# Newmar Corporation

RSB 608  
JAN 23, 2024

NHTSA #24V 019  
TC #2024-016

## RECALL SERVICE BULLETIN

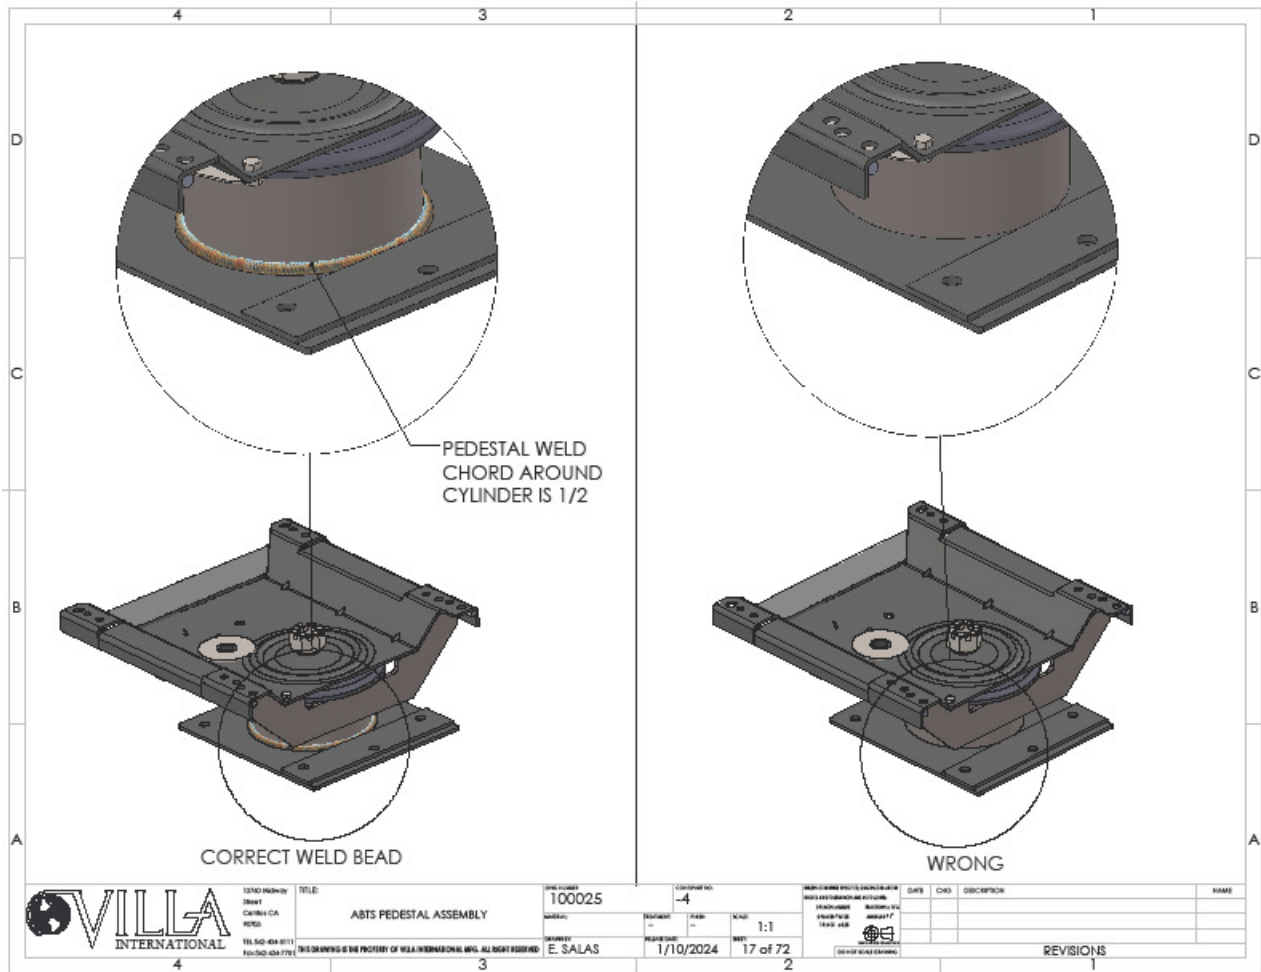
The safety defect involves the pedestal used on Villa ABTS driver and passenger seating where the seat assembly is attached to the pedestal and serves as an anchorage to the vehicle. On certain seat pedestals the can may be improperly welded to the mounting plate. The pedestal in the affected seat assemblies could fail in the event of a vehicular collision.

Inspection of the seats in the vehicles listed above is necessary in order to identify if a repair is required on Villa driver and passenger seats. Attached with this notification is a drawing to help identify the defective pedestal.

**If the vehicle inspection reveals that the pedestal does have the improper weld, then the pedestal is required to be replaced for that seat.**
